Rezoning Transportation Analysis

Petition Number: 2020-112

Revision Log:

Date	Description
09-11-20	First Review (EL)
04-15-21	Second Review (EL)
8-25-21	Third Review (BB)
9-21-21	Fourth Review (BB)

FIGURE 1 & 2: Recommended Street cross-sections

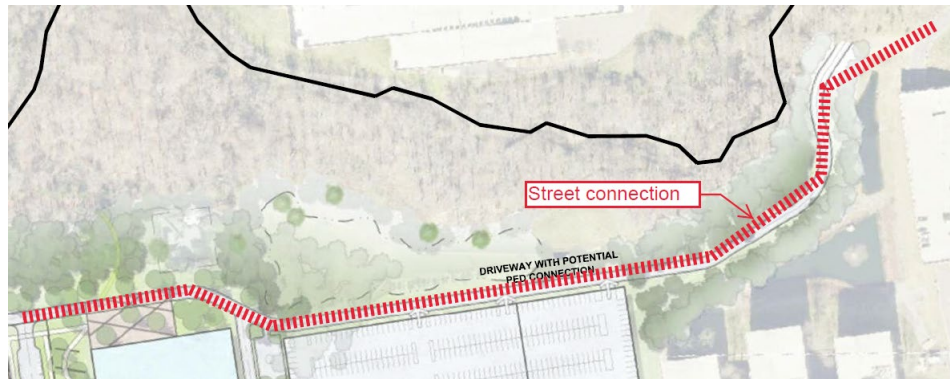
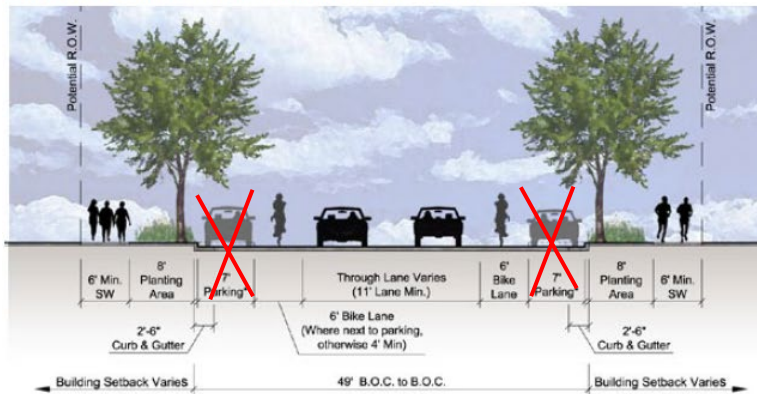
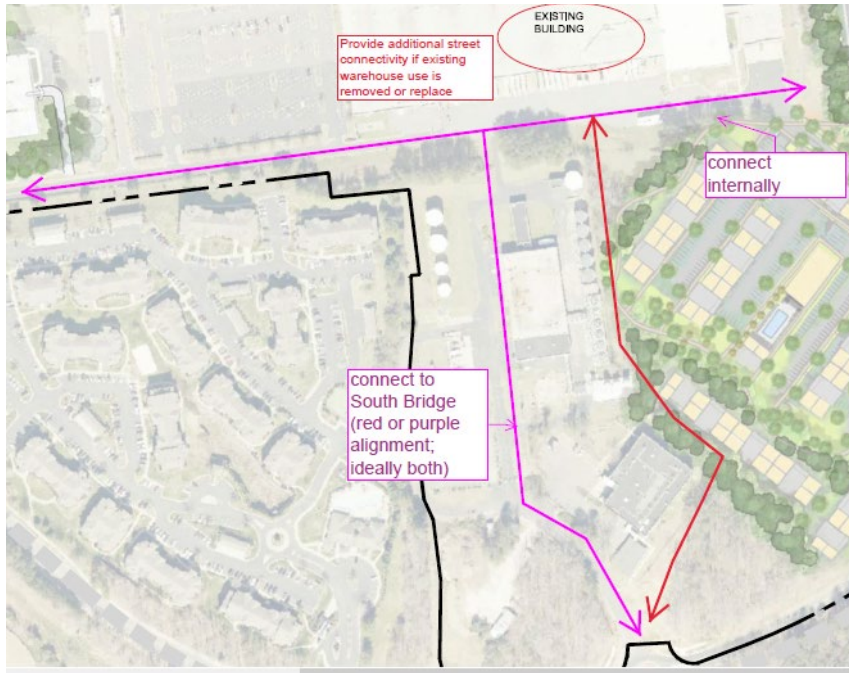
5. **Outstanding (Site plan dated 8/16/21):** Revise "Proposed Public Road D" cross-section to include a 6' bike lane. The site plan and conditional note(s) need to establish a street connection, as shown below, according to the proposed avenue cross section that is recommended within the University Research Park Area Plan. Refer to pages 38 and 41.

- 49-foot Back of Curb to Back of Curb
Min. 77-foot right-of-way
- 6-foot Sidewalk: Improved pedestrian realm, compliant with ADA (Americans with Disabilities Act)
- Bike Lane: 4-foot Min, 6-foot where on street parking is present - safer bicyclists realm, improved truck turning radius, additional buffer for pedestrians
- Planting area: Buffer for pedestrians; beautification
- On street parking: additional buffer for pedestrians, shared parking, active streetscape

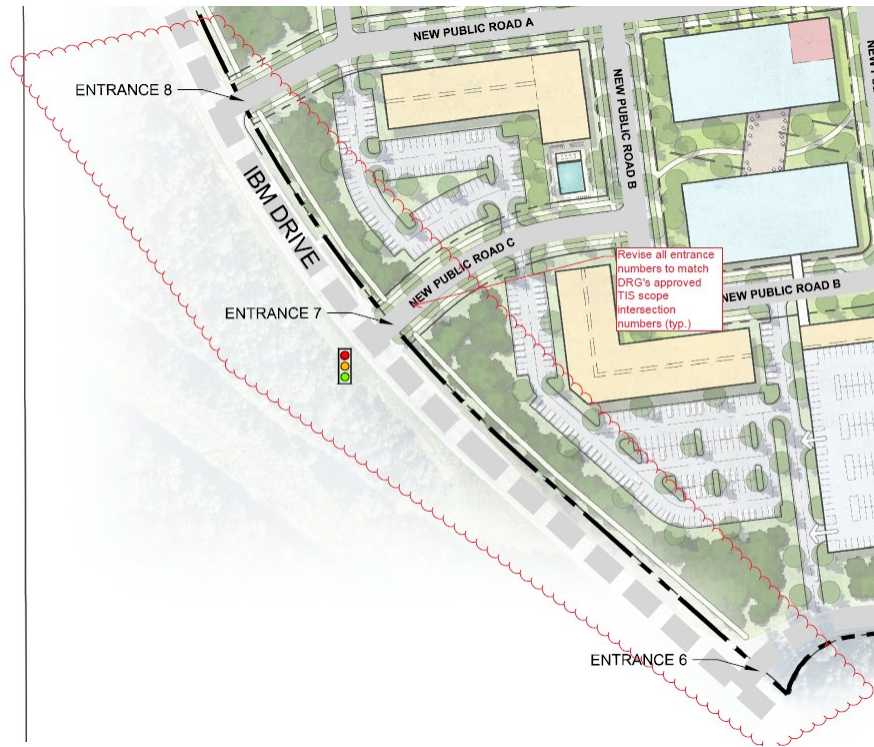
7. Provide additional street connectivity to the north leg of the existing roundabout at the intersection of IBM Drive and University Pointe Boulevard, in the event the existing warehouse use circled below is removed or replaced. These street connections are important to redistribute traffic to multiple access points along IBM Drive.
